SUBJECT: NEW VEHICLE DEMONSTRATION / DELIVERY HOLD - Safety Recall 22S47
Certain 2021-2022 Model Year Corsair, 2020-2022 Model Year Escape and 2022 Model Year Maverick Vehicles Equipped with a 2.5L HEV/PHEV Engine Under Hood Fire

NEW VEHICLE DEMONSTRATION / DELIVERY HOLD - Safety Recall 22S47
Certain 2021-2022 Model Year Corsair, 2020-2022 Model Year Escape and 2022 Model Year
Maverick Vehicles Equipped with a 2.5L HEV/PHEV Engine - Under Hood Fire

FIGURE 1

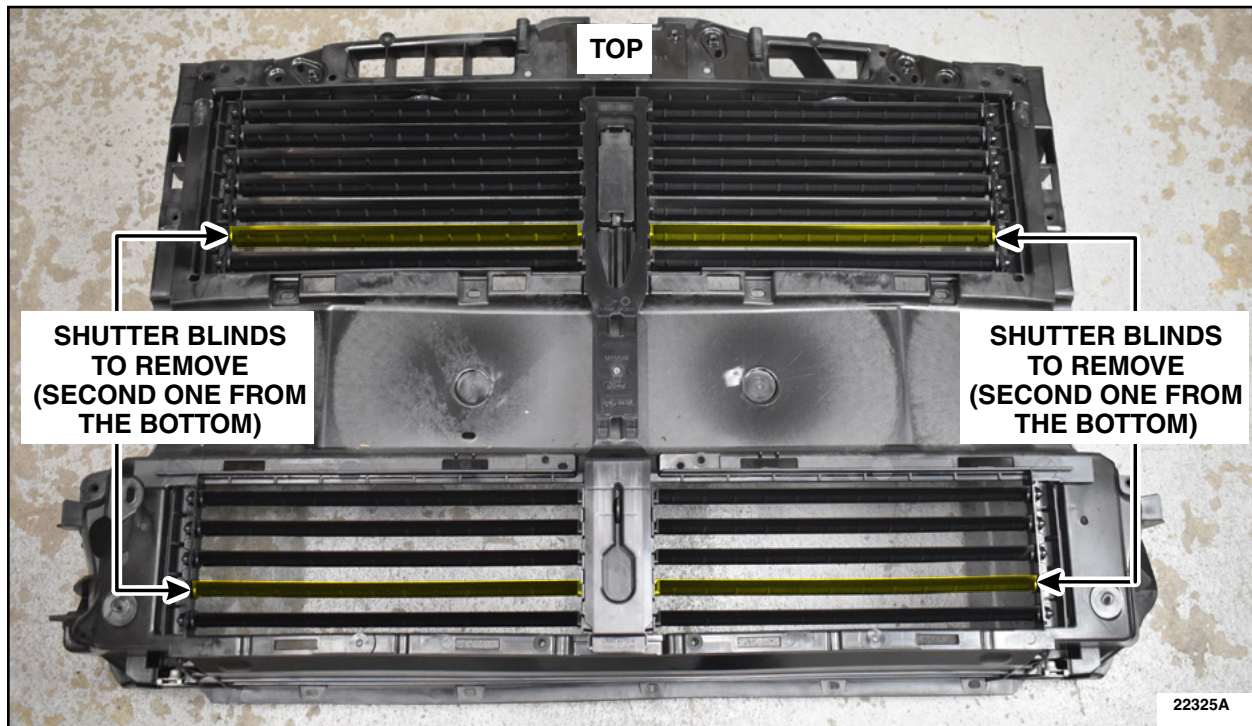
2. Remove the four required shutter blinds. See Figures 1, 2, 3 and 4.

- First, bend the shutter blind at center and pull toward the front of the vehicle, then remove the OUTBOARD side tab from hole in housing.
- Second, pull to dislodge the INBOARD side tabs via pulling toward outboard the side of vehicle and remove the shutter blind.
- Third, verify all remaining shutter blinds move and do not bind.

FIGURE 4

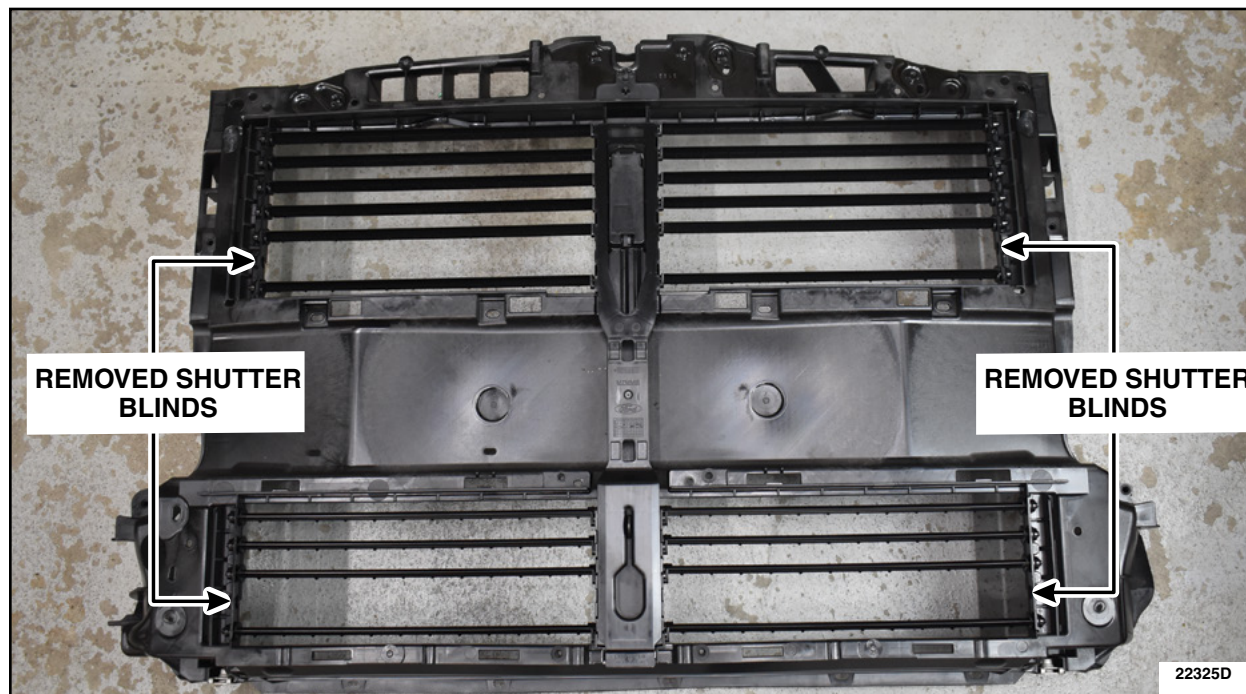
Completed AGS Assembly Modification

FIGURE 5

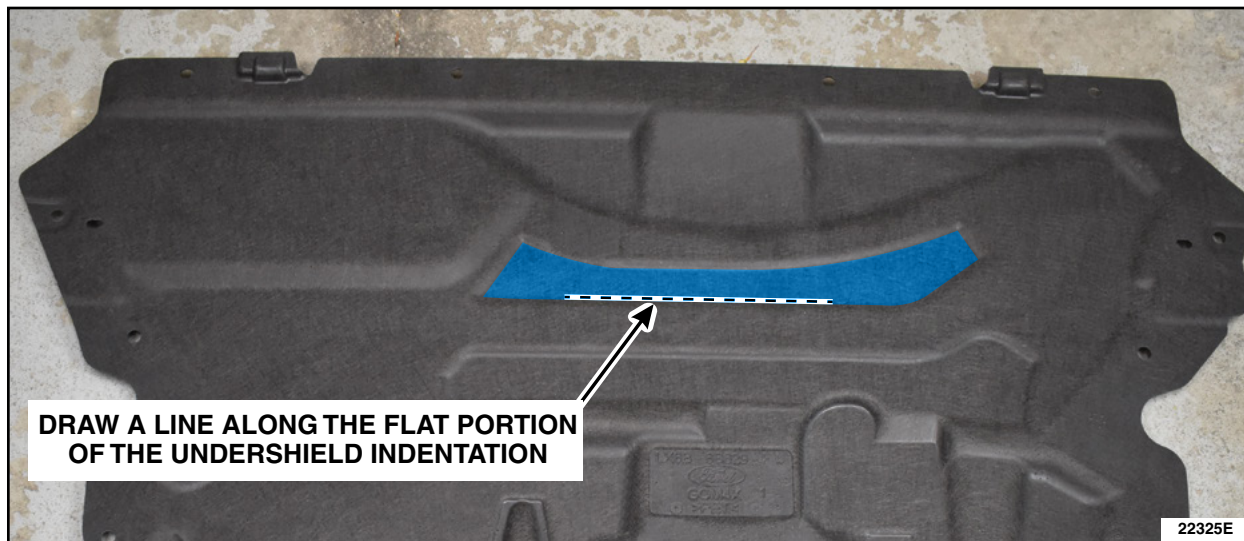
6. Using a liquid paint marker or equivalent, draw a line on the engine front undershield along the flat inner edge of the indentation as shown in Figure 5.

FIGURE 6

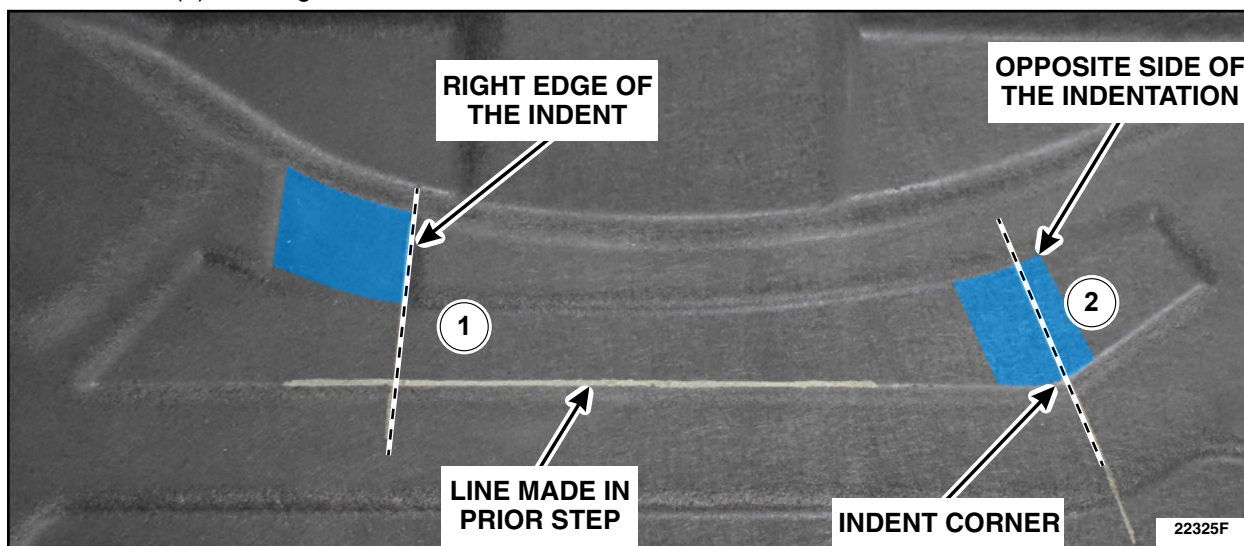
7. Using a liquid paint marker or equivalent and a flat edge, draw a line from the right edge of the indent to the line made in the prior step (1). Draw a line from the indent corner to the opposite side of the indentation (2). See Figure 6.

FIGURE 7

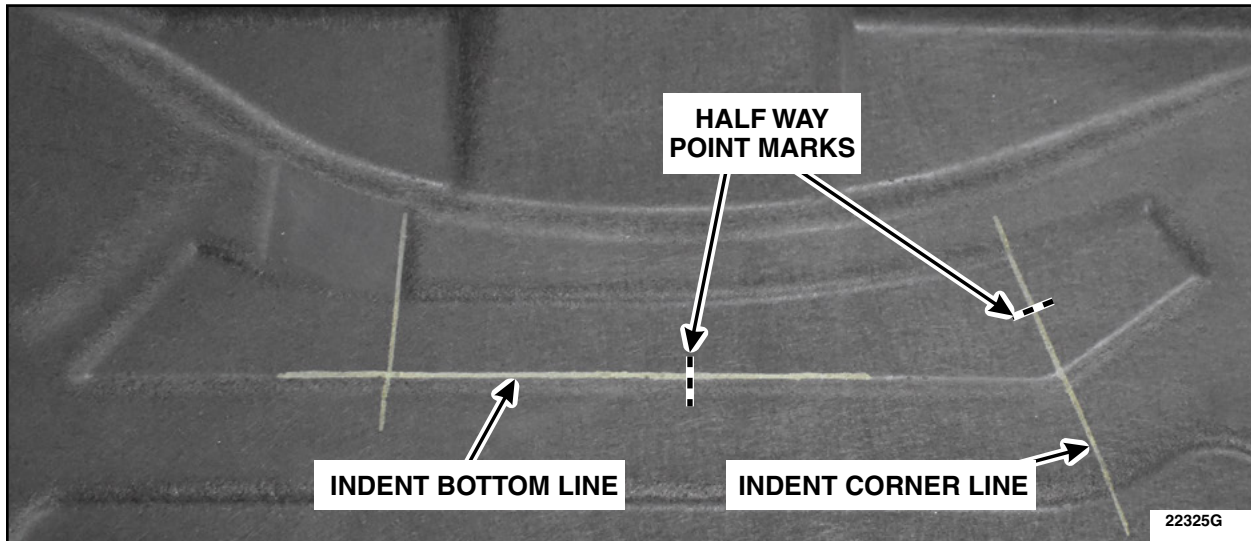
8. Using a liquid paint marker or equivalent, put a mark at the half way point on the indent bottom line and on the indent corner line (right side). See Figure 7.

FIGURE 8

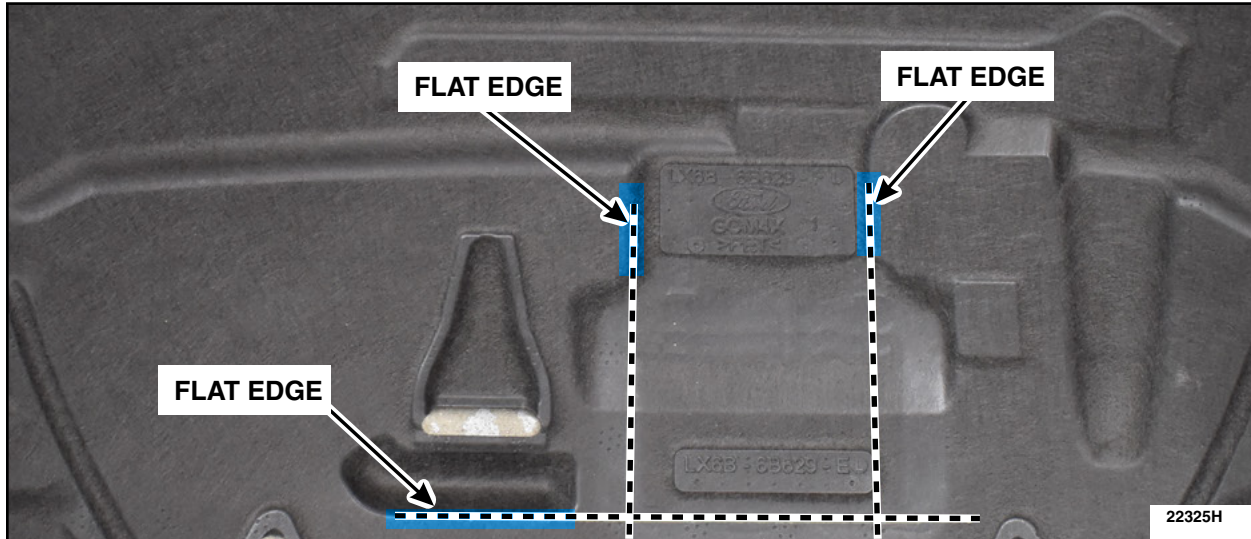
9. Using a liquid paint marker or equivalent and a flat edge, draw 3 lines using the flat side of the indentations shown. See Figure 8.

FIGURE 9

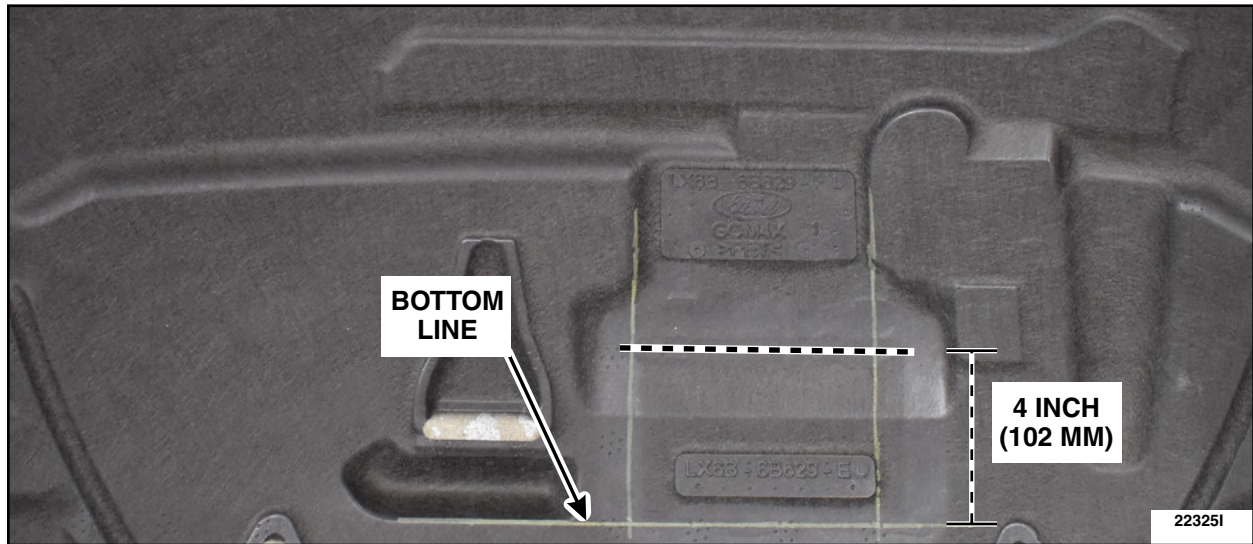
10. Draw a line 4 in (102 mm) up from the bottom line. See Figure 9.

FIGURE 10

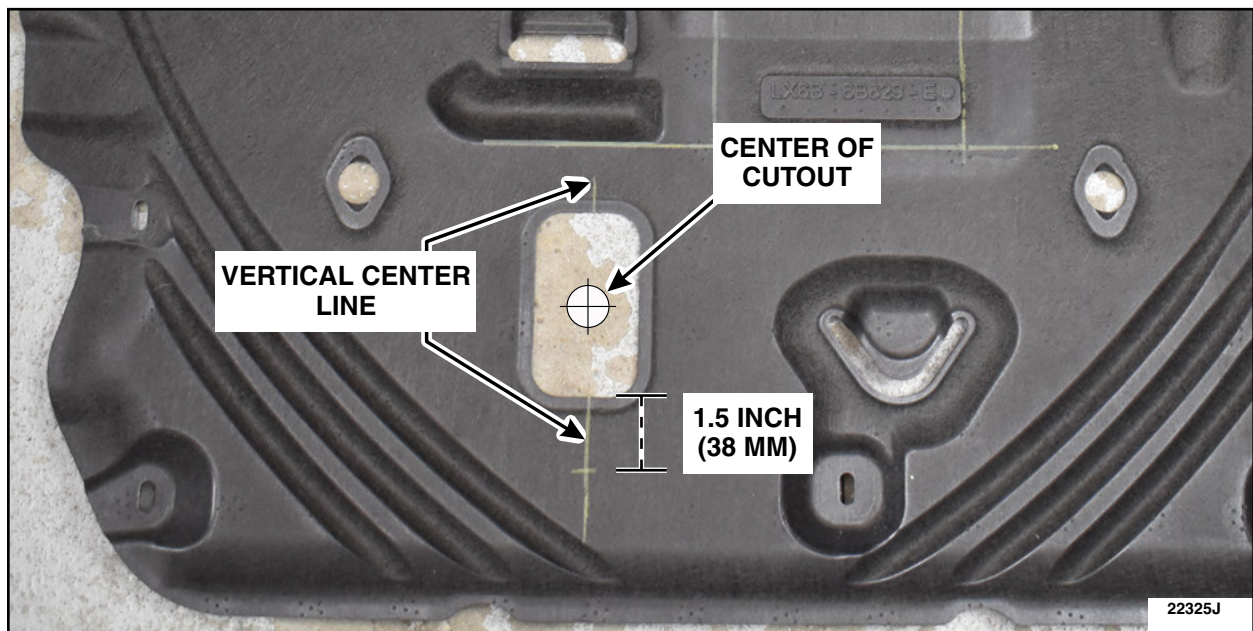
11. Find the center of the cutout and draw a line for vertical center. Measure from the bottom edge of the cut out 1.5 in (38 mm). See Figure 10.

FIGURE 11

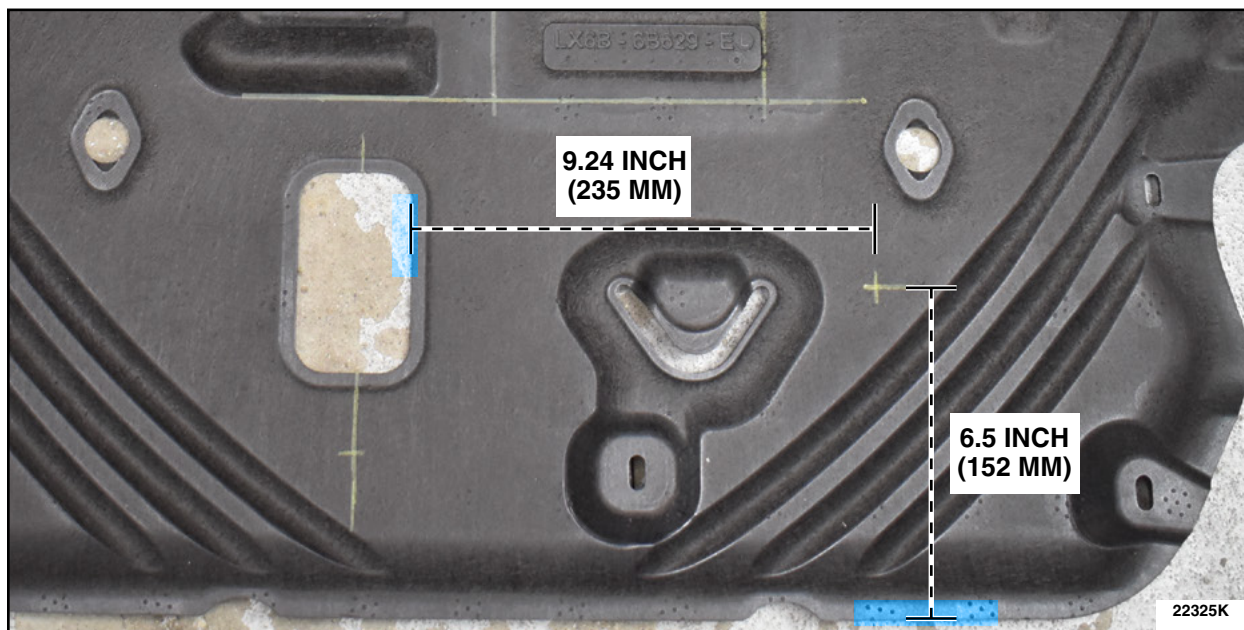
12. Measure 9.25 in (235 mm) from the cut out and 6.5 in (152 mm) from the edge of the shield.
See Figure 11.

FIGURE 12

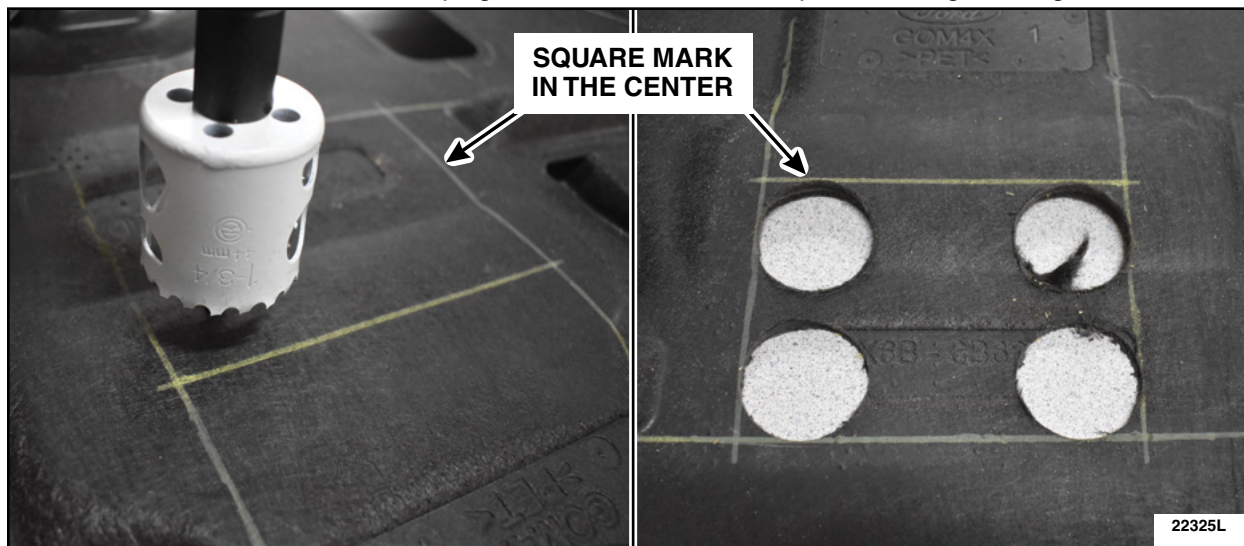
13. On the square mark in the center, using a 1-3/4 inch (44 mm) Bi-Metal Hole Saw with arbor and pilot bit, drill a hole in each corner keeping the hole saw within the square marking. See Figure 12.

FIGURE 13

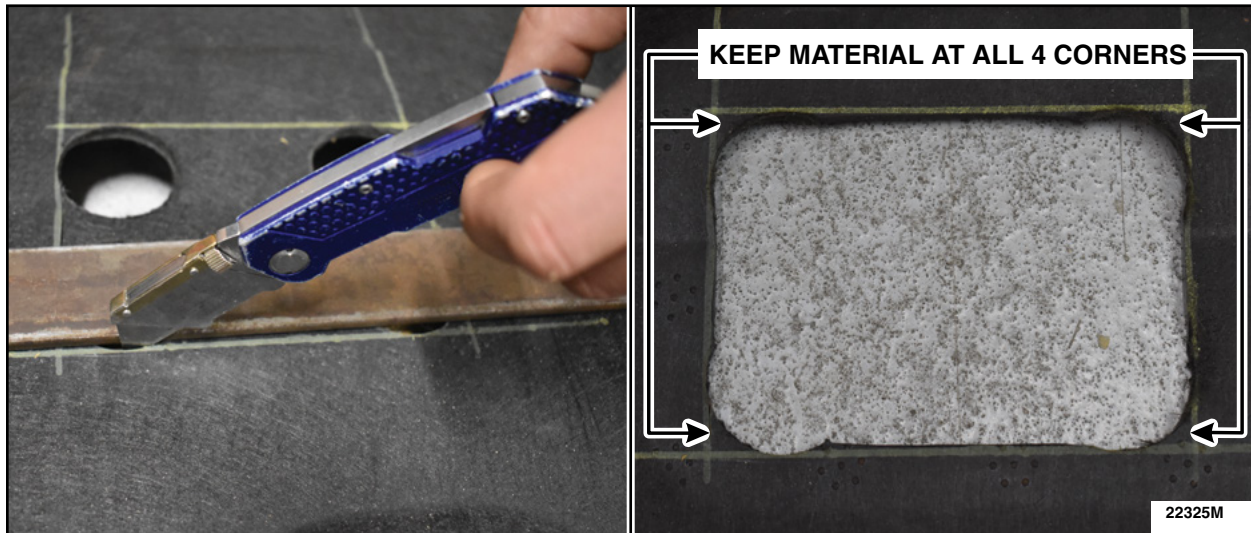
14. Using a straight edge and a utility knife, cut out the underbody shield material left between the 4 holes made within the square. See Figure 13.

FIGURE 14

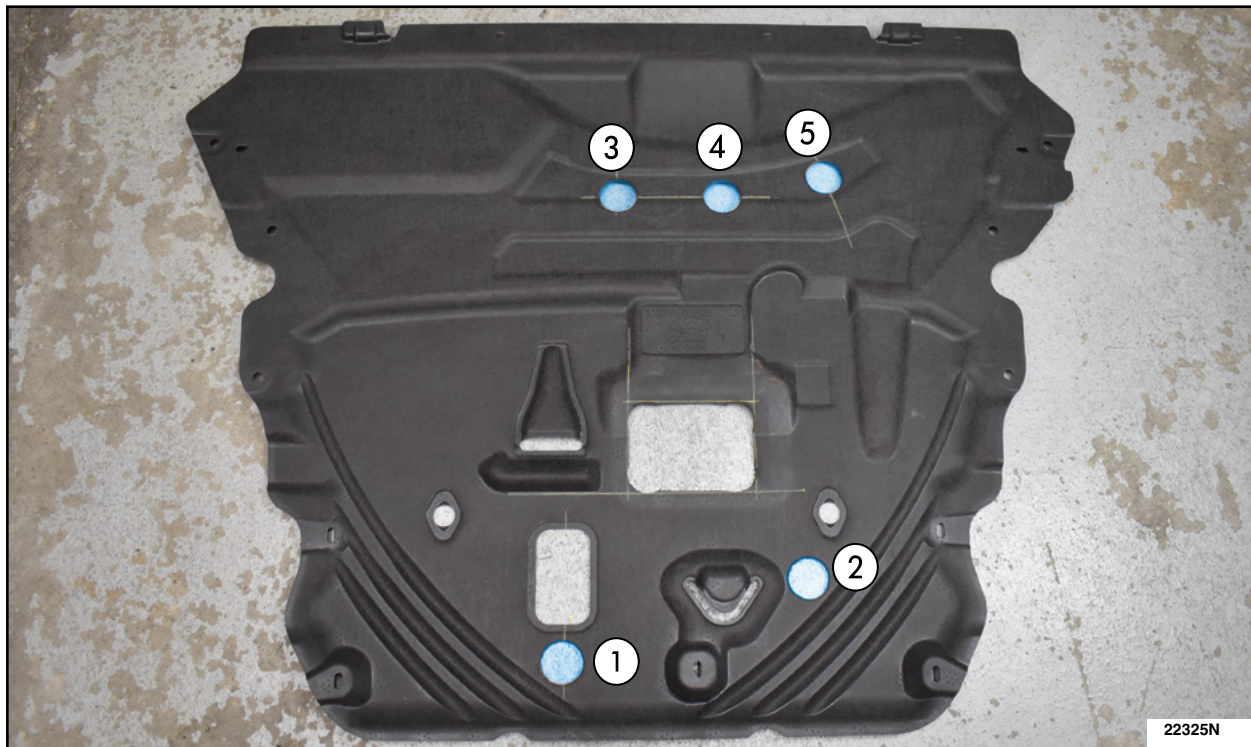
15. Using a 1-3/4 inch (44 mm) Bi-Metal Hole Saw with arbor and pilot bit, drill out the remaining 5 holes. See Figure 14.

FIGURE 15

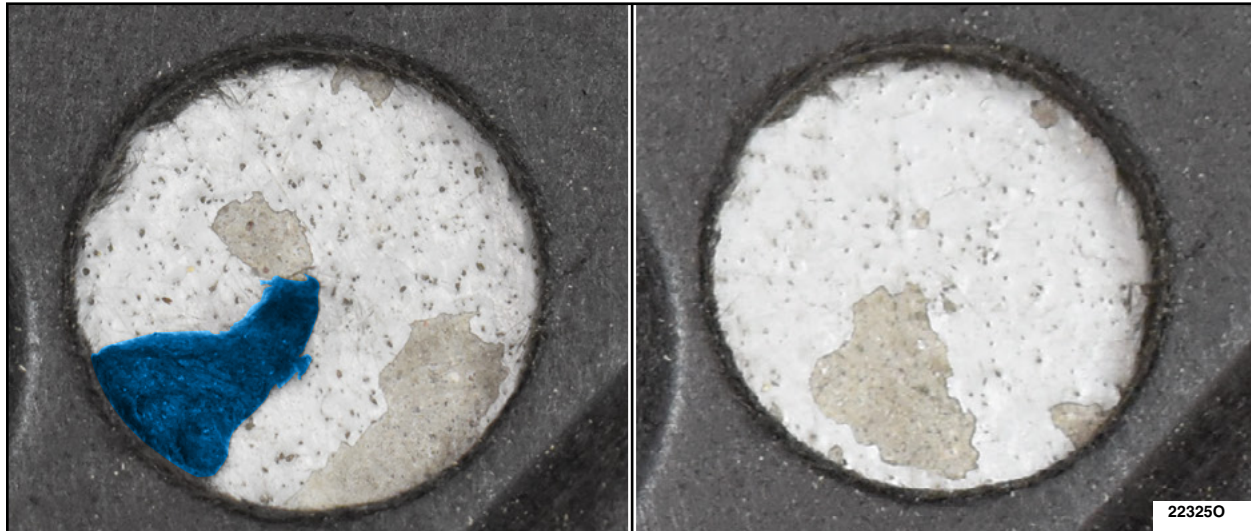
16. Using a utility knife, clean up any burrs and stray pieces of underbody shield material in any holes drilled. See Figure 15.
